CONSERVATION COMMISSION AGENDA

The Conservation Commission will hold this meeting as a virtual meeting on Thursday, September 17, 2020 at 7:00 pm. No in-person meeting will take place at City Hall.

39 NORWOOD AVE -

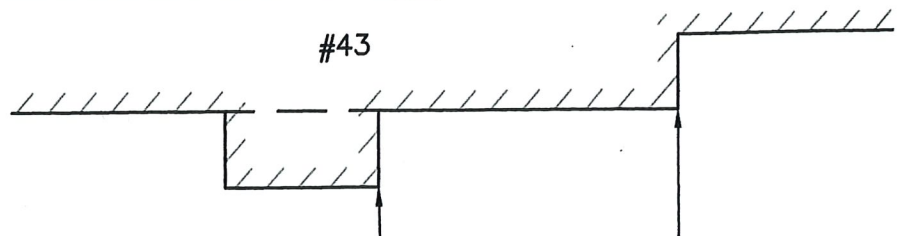
- There are some inconsistencies in the planting schedule that should be corrected, as shown in the packet.
 - Staff feel that the existing and proposed patio is pervious, and therefore the existing (im)pervious area calculations are incorrect. Staff estimate that the increase in impervious area is closer to 489.5 s.f. The Commission should determine if the proposed mitigation is sufficient for this increase in impervious area.

- Staff Recommendations: Once questions are addressed, vote to close the hearing and issue an Order of Conditions with the standard landscape conditions.

210 UPLAND AVE - PROPOSED CONDITIONS

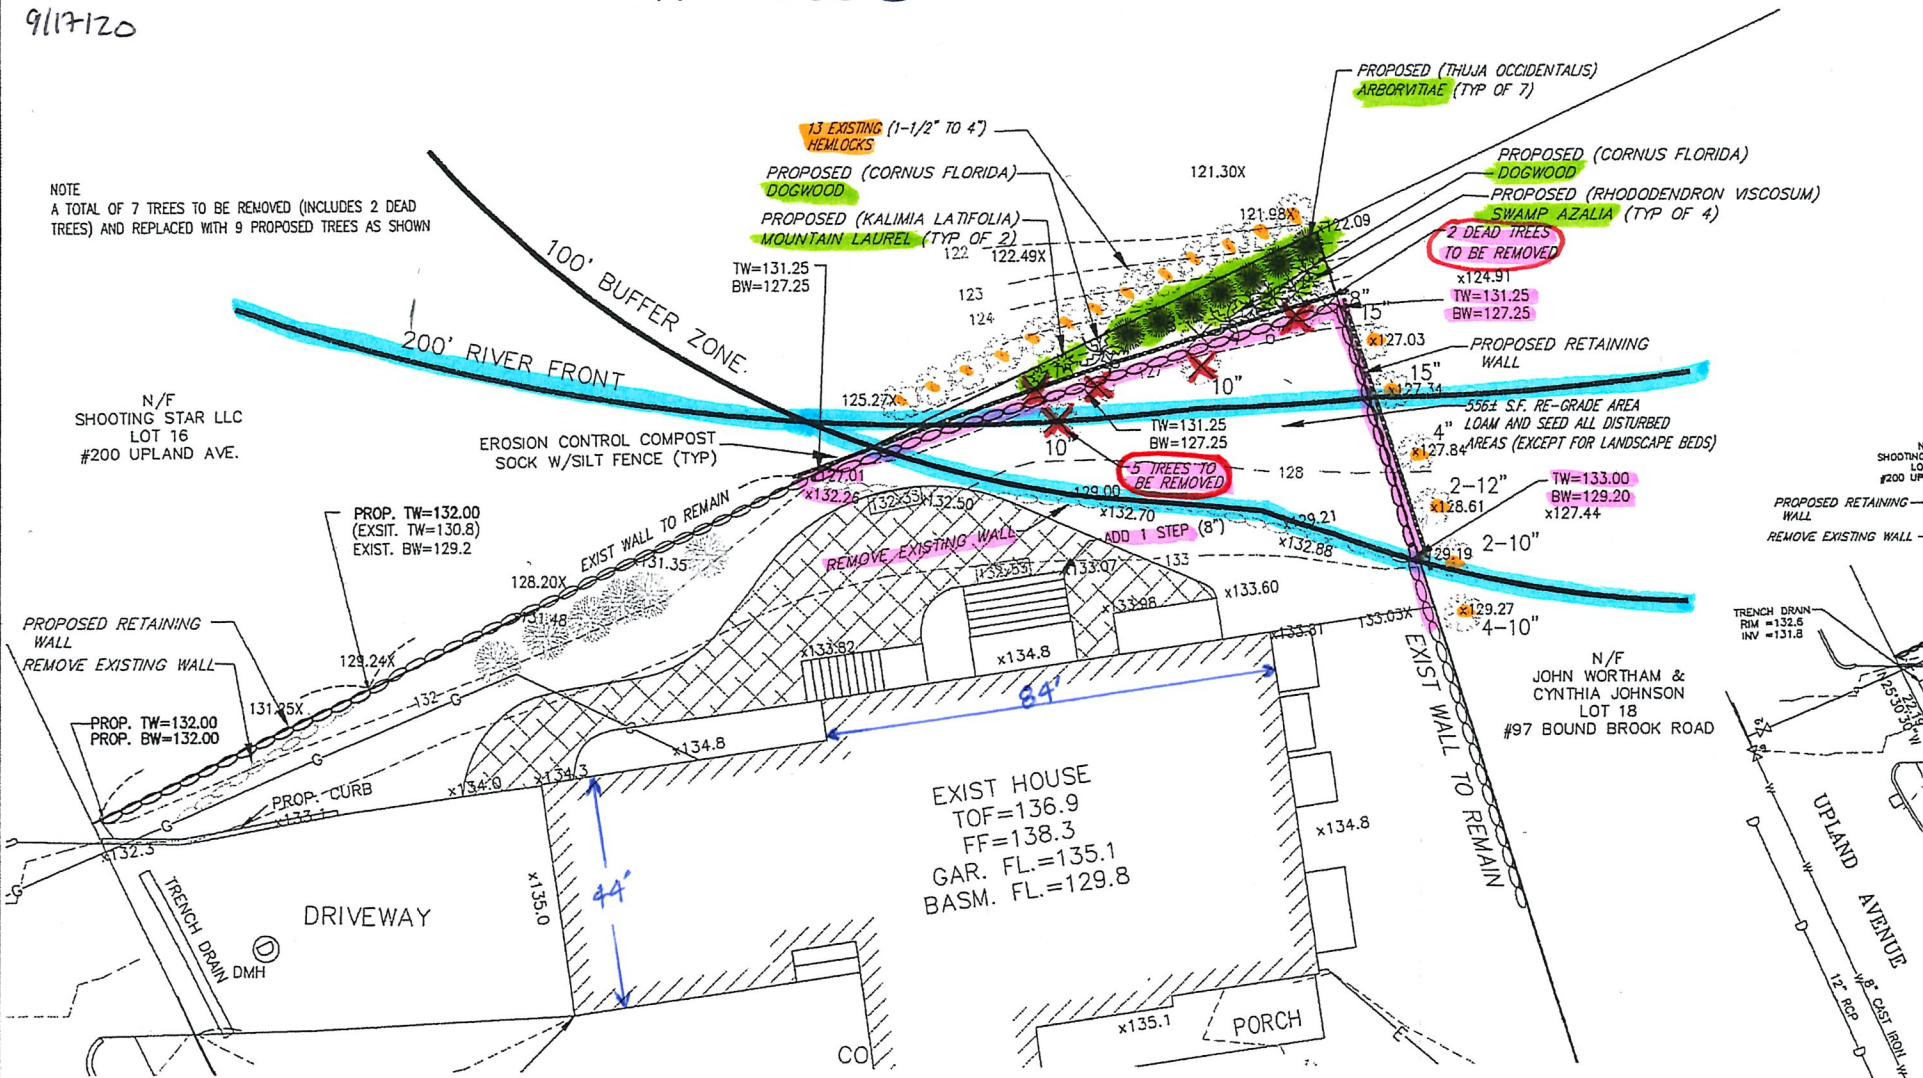
- Staff Notes:
 - The applicant has significantly reduced the height of the proposed retaining wall and has added appropriate mitigation plants.
 - Staff remain concerned about the existing trees on the adjacent lot of 97 Bound Brook, whose roots will be impacted by the installation of the retaining wall and other construction activities.

- Staff Recommendations: Vote to close the hearing and issue and Order of Conditions.

35 WAYNE ROAD - PROPOSED ACCESS

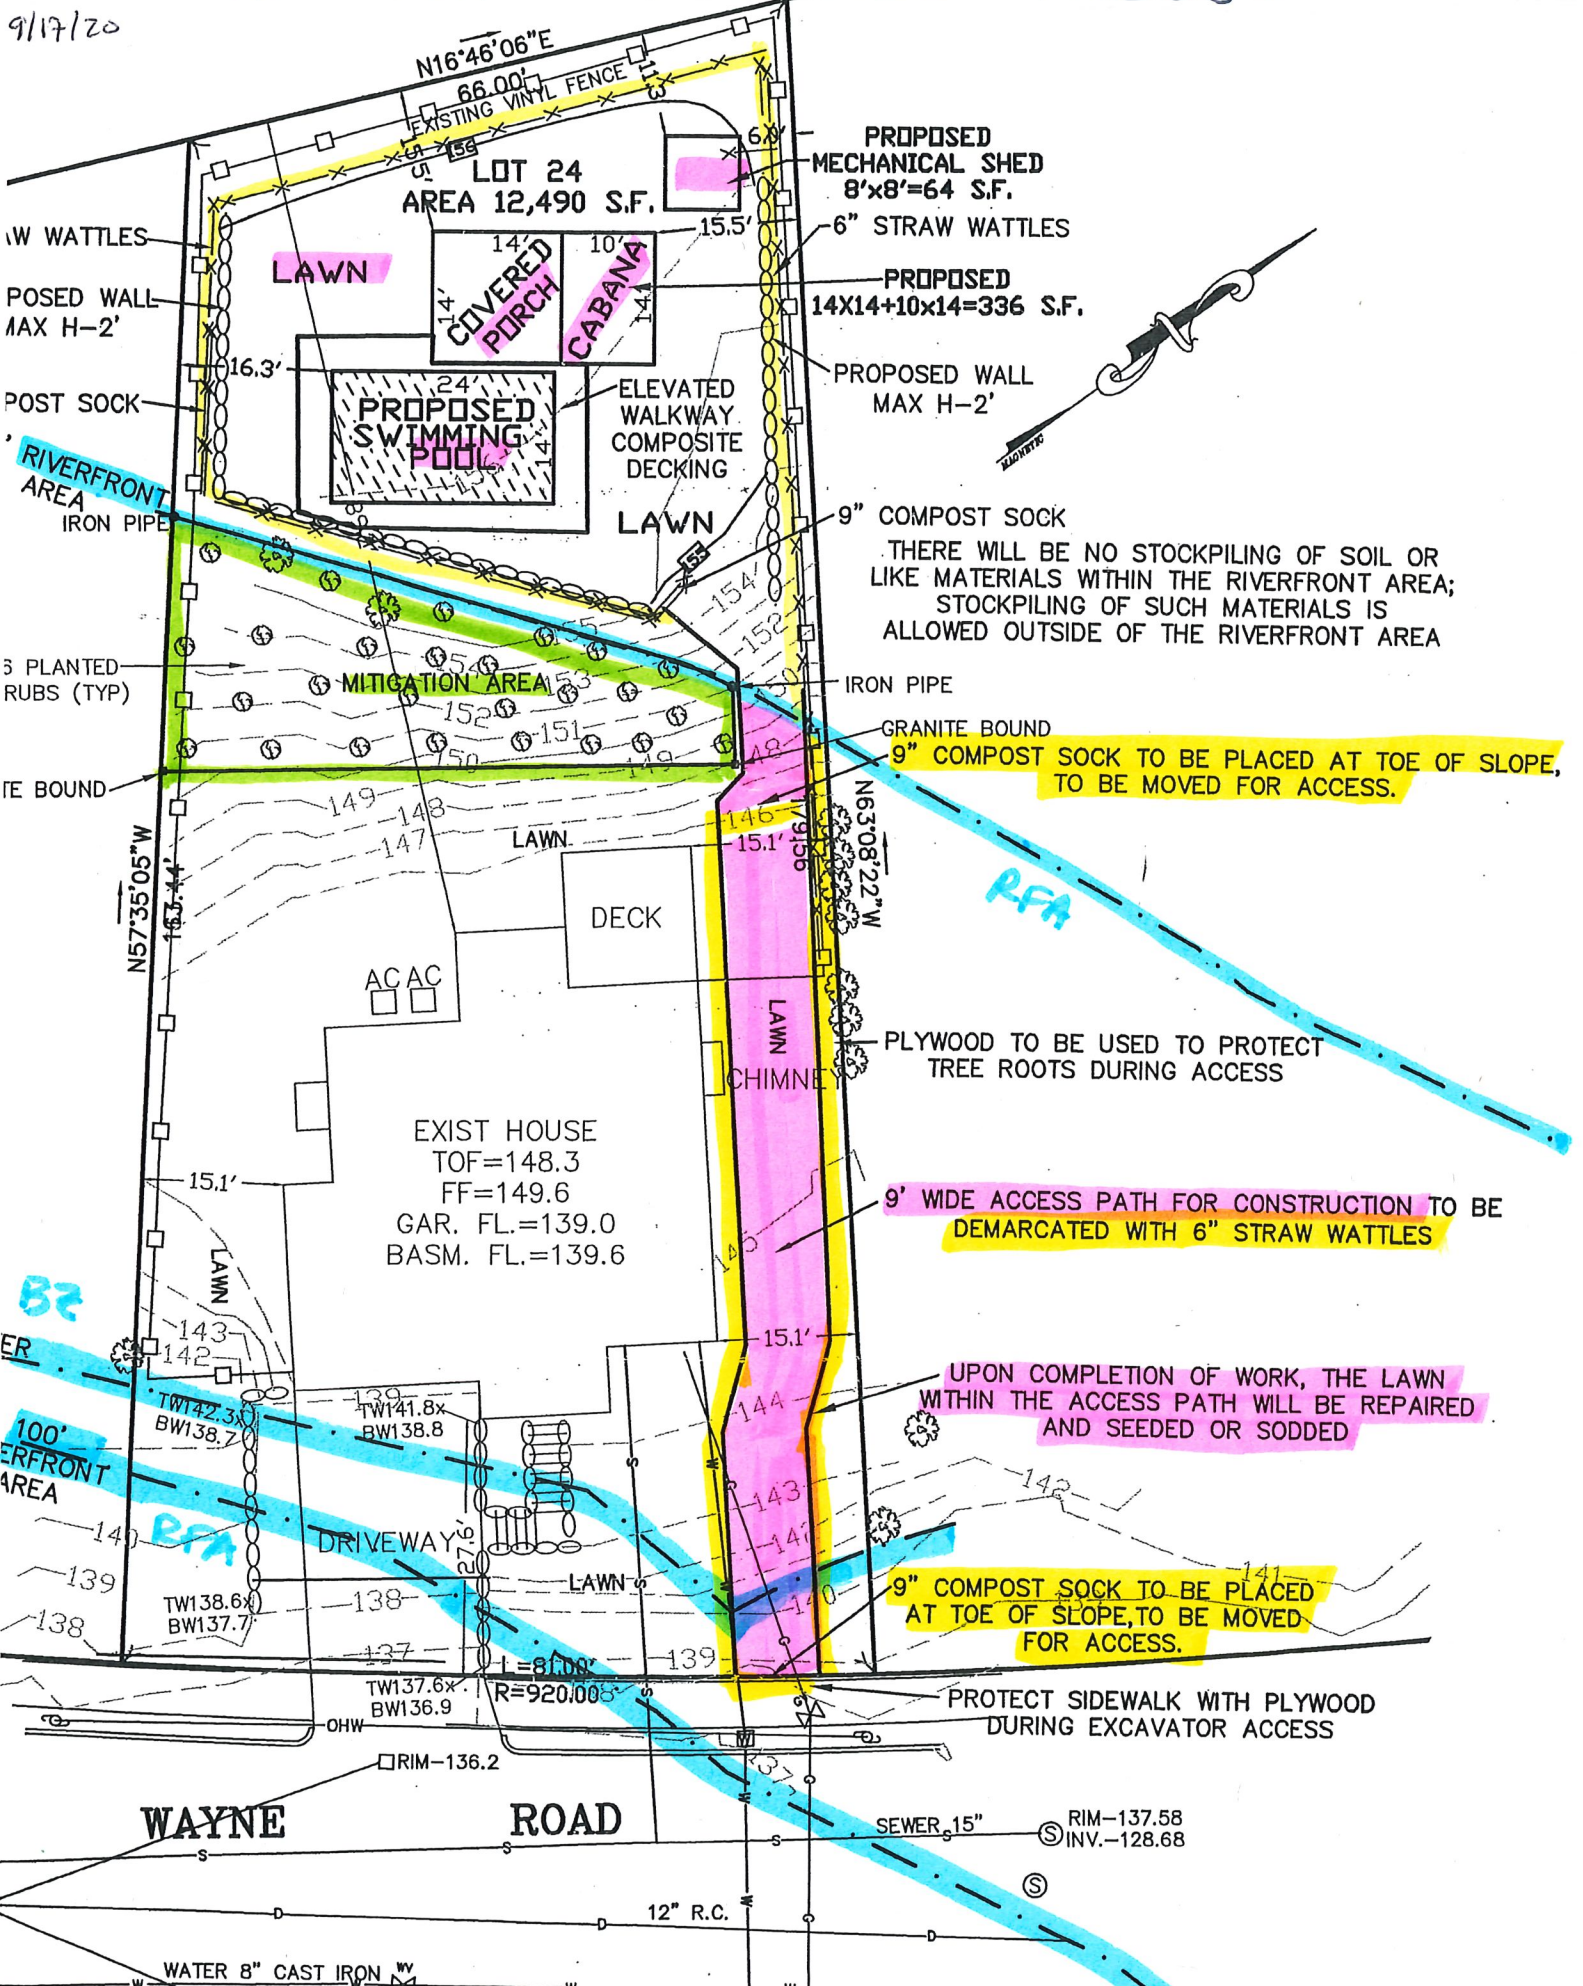
- No disturbance of the bounded mitigation area is proposed.
 - Staff Notes
 - Staff are concerned about the topography of the access; it is steeply sloped towards the neighbor to the east – stability of equipment and erosion controls must be better addressed.

- Staff are concerned that access past the bounded mitigation area is very tight.
 - Staff note that there are three saplings along the eastern property boundary that must be adequately protected. Currently, no protection is shown.

- Staff do have concerns about the retaining wall impact on the roots of the mitigation plantings.
 - Staff are concerned about the likely presence of ledge in the area of the proposed pool. Large equipment may be needed to traverse the access path if blasting is necessary.

- Staff Recommendations: Vote to issue a negative 3 Determination of Applicability with the following conditions only if all concerns are adequately addressed.

- Applicant must schedule a pre-construction site visit to ensure that the access lane is properly marked and that erosion controls are properly installed.

- Should any of the shrubs or trees within the mitigation area die within two years of construction or are shown to have been demonstrably harmed by the construction, they will be replaced at a ratio of 2:1.

2344 WASHINGTON ST. and
PAVING PLAN -- 2310 WASHINGTON ST -- 8/31/20

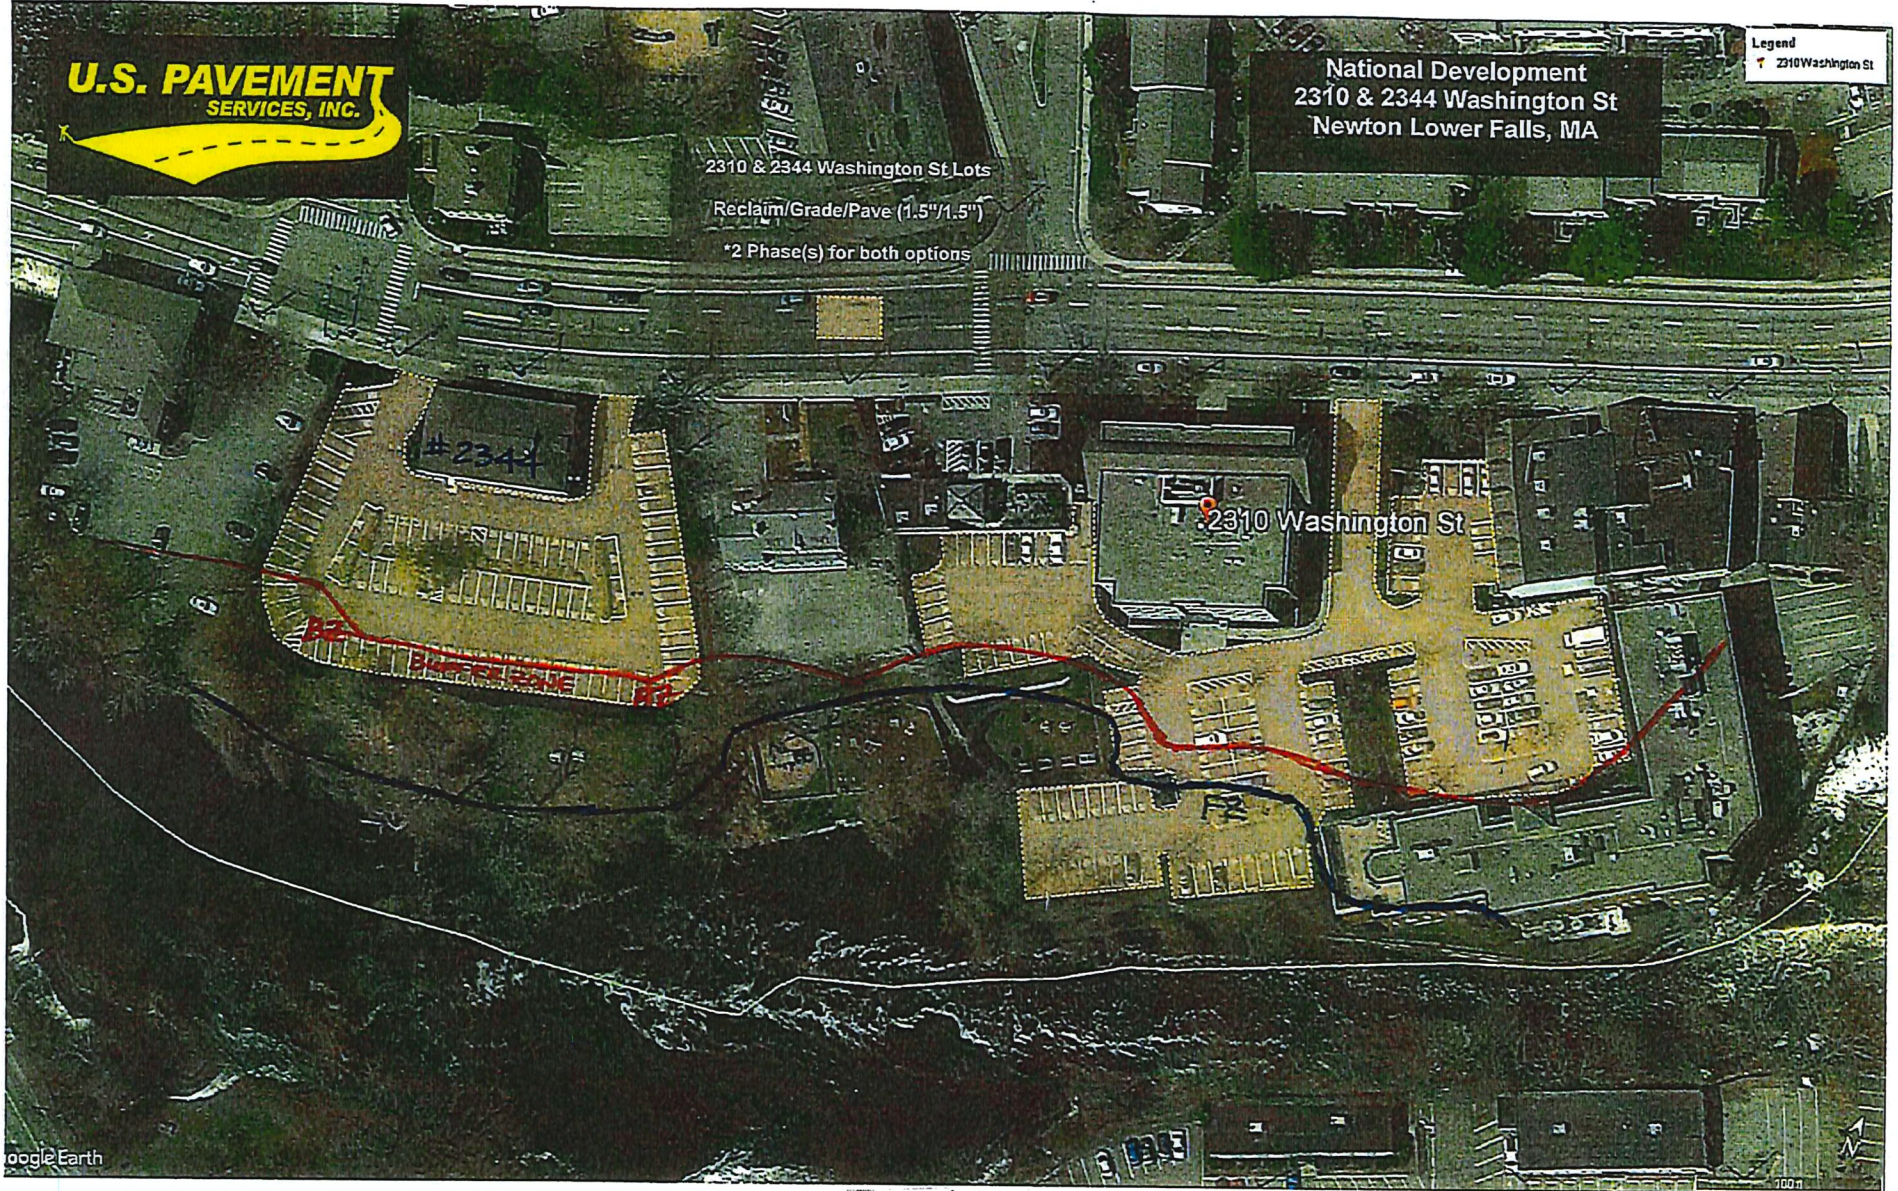
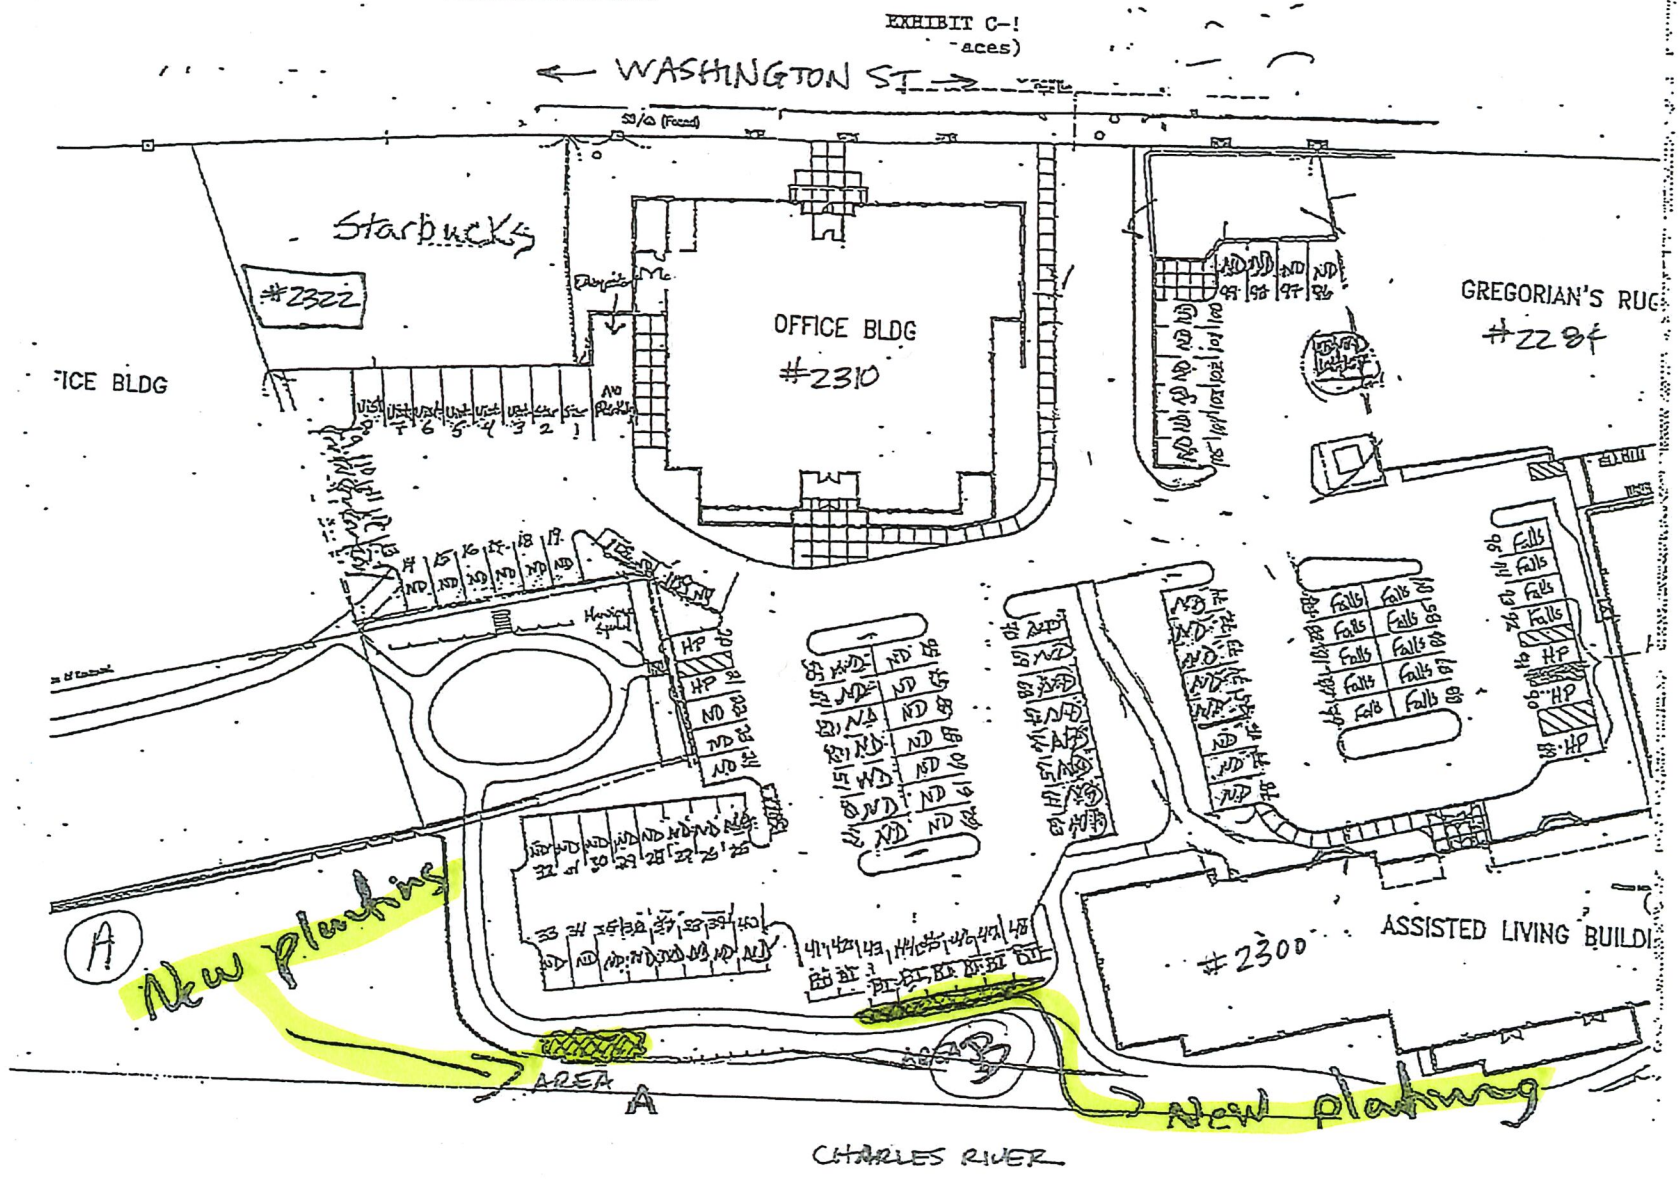
- Staff feel this project is fully approvable under an RDA and would have been administratively approved if not for the BLSF. Since the final grades will not be altered and since the applicant is proposing stormwater improvements, it seems to be an approvable project.

- Staff Recommendations: Vote to issue a negative 2 Determination of Applicability.
- 6. 51 Oakland Ave – COC – additions to SFH and new patio– DEP File #239-809**
